[Docket No. 99–SW–80–AD; Amendment 39–12983; AD 2002–25–07]

Airworthiness Directives; Bell Helicopter Textron Canada Limited Model 206L, L–1, L–3, and L–4 Helicopters

ACTION: Final rule.

Figure 1**BILLING CODE 4910-13-C**

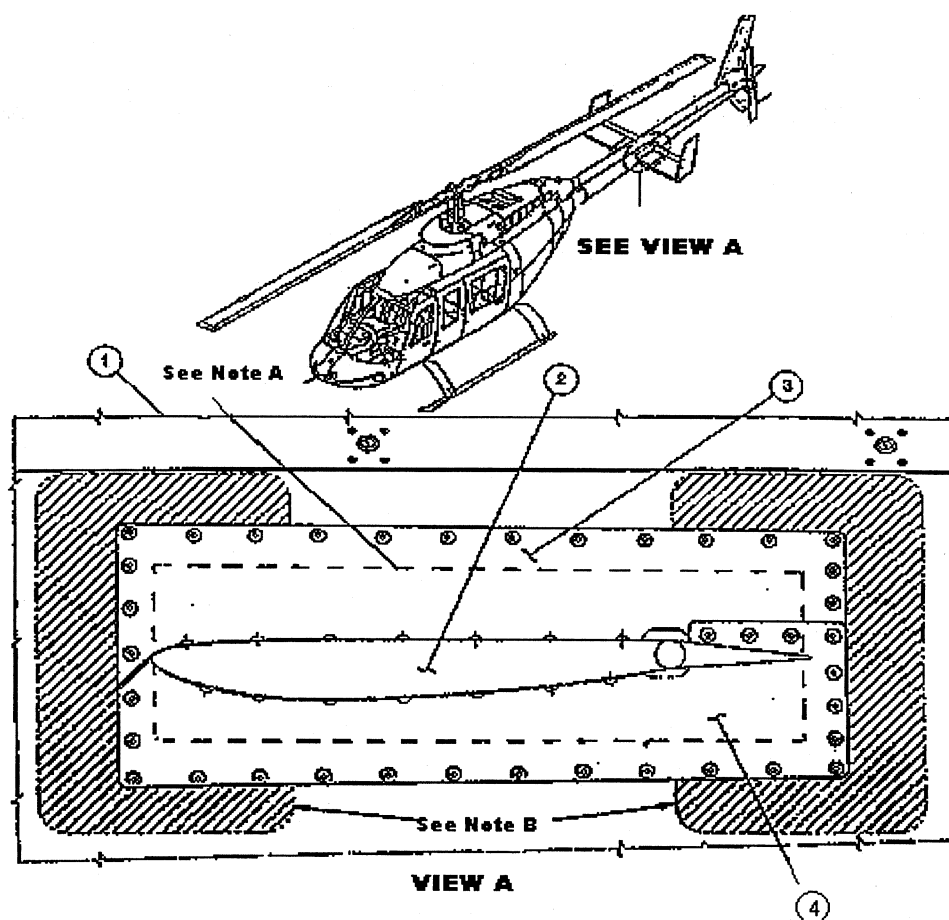
(a) Before further flight and thereafter at intervals not to exceed 10 hours time-in-service (TIS) until accomplishing a one-time fluorescent-penetrant inspection (FPI) required by paragraph (c)(2) of this AD, visually inspect for a crack in the tailboom using a 10-power or higher magnifying glass in the shaded areas as depicted in Figure 1 of this AD:

(b) At intervals not to exceed 5 hours TIS, visually check for a crack in the tailboom in the shaded areas as depicted in Figure 1 of this AD. The visual check may be performed by an owner/operator (pilot) holding at least a private pilot certificate and must be entered

(2) Perform a one-time FPI of the edges of the tailboom skins for any crack around the left and right horizontal stabilizer openings as shown in Figure 1 of this AD. Remove paint and primer to inspect the edges and

exterior skin surface in the skin area at least $\frac{3}{4}$ inch around the edges of the horizontal stabilizer openings as shown in Figure 1 of this AD.

(2) Visually inspect the entire edge of the horizontal stabilizer opening on both sides of the tailboom for any crack using a 10-power or higher magnifying glass as shown in Figure 1 of this AD.

- A. Inspect entire edge of stabilizer opening on both sides of the tailboom.
- B. Inspect for a crack in these two areas on both sides of the tailboom
